Access Compliance Report

Public Rights-of-Way

Intersection ID: 2963	Main Street: MADISON_PARK_DR	Cross Street: WHITE_ASPEN_PL	Location: W
ADA ID: 5F1C965D1023	Ramp Type: Perp	Initial Pass/Fail: Fail	Overall Compliance: No
		Severity Score: 25

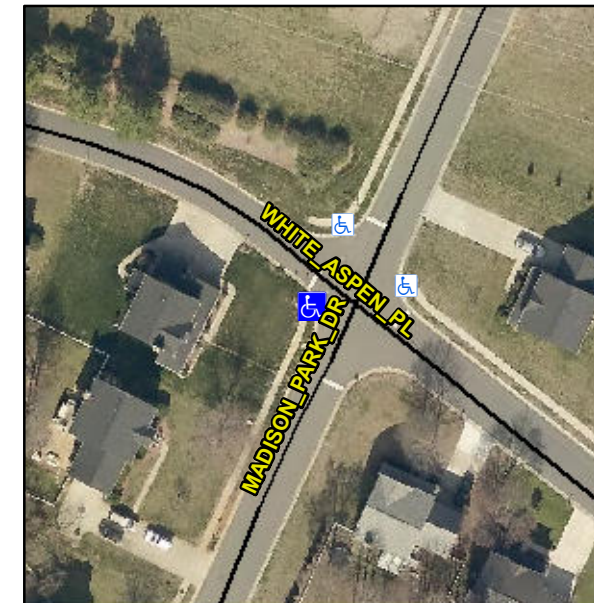
Not Found, R304.5.3

Compliance	Description	Data	Compliance	Description	Data
N/A	Ramp Length (in)	48.0	Yes	Ramp Slope (%)	7.2
Yes	Ramp Width (in)	48.0	No	Ramp XSlope (%)	8.1
N/A	Flare Type LT	N/A	N/A	Flare Type RT	N/A
N/A	Flare Slope LT (%)	N/A	N/A	Flare Slope RT (%)	N/A
N/A	Flare Traversable LT?	N/A	N/A	Flare Traversable RT?	N/A
N/A	Landing Length (in)	N/A	N/A	DWS Provided?	N/A
N/A	Landing Width (in)	N/A	N/A	DWS Contrast?	N/A
N/A	Landing Slope (%)	N/A	N/A	DWS Length (in)	N/A
N/A	Landing X Slope (%)	N/A	N/A	DWS Full Width?	N/A
N/A	Landing Curb? (Y/N)	N/A	N/A	DWS Offset (in)	N/A
N/A	Shared Landing?	N/A			
N/A	Gutter Ponding?	N/A	N/A	Gutter Slope (%)	N/A
N/A	Gutter Lip Ht (in)	N/A	N/A	Gutter X Slope (%)	N/A
N/A	Painted X Walk1?	No	N/A	Painted X Walk2?	N/A
	X Walk 1 Direction	To NE		X Walk 2 Direction	N/A
N/A	X Walk 1 Width (in)	N/A	N/A	X Walk 2 Width (in)	N/A
	X Walk 1 Slope (%)	5.9		X Walk 2 Slope (%)	N/A
	X Walk 1 X Slope (%)	3.0		X Walk 2 X Slope (%)	N/A

Remove & Replace Entire Ramp.
